India's comments on Doc. ECE/TRANS/WP.29/GRE/2015/6 - proposal submitted by the expert from Poland for Supplement to Regulation No. 48 (Installation of lighting and light-signalling) to introduce "side illuminating lamps".

Figure 1.: At road intersection, additional white light from side should not cause undue glare and also confusion to oncoming vehicle as white light will be visible from side of vehicle.

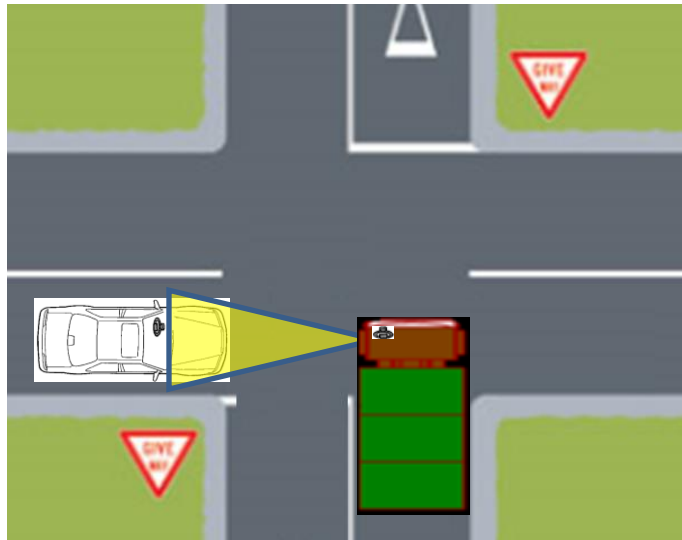
- B.2 The position of “side illuminating lamp” should be such that it doesn’t cause discomfort to the driver coming from side at any road intersection.

This is explained by Figure 1 below:

" 6.27.4. Position

In height:

Minimum	:	Not less than 400 mm above the ground;
Maximum	:	Not more than 900 mm above the ground.

In Length: on the side of the vehicle as per paragraph. 2.7.26.2.above.

This requirement shall be deemed to be satisfied if the light emitted does not cause discomfort to the driver of oncoming vehicle in the lamp installed on side of the vehicle.
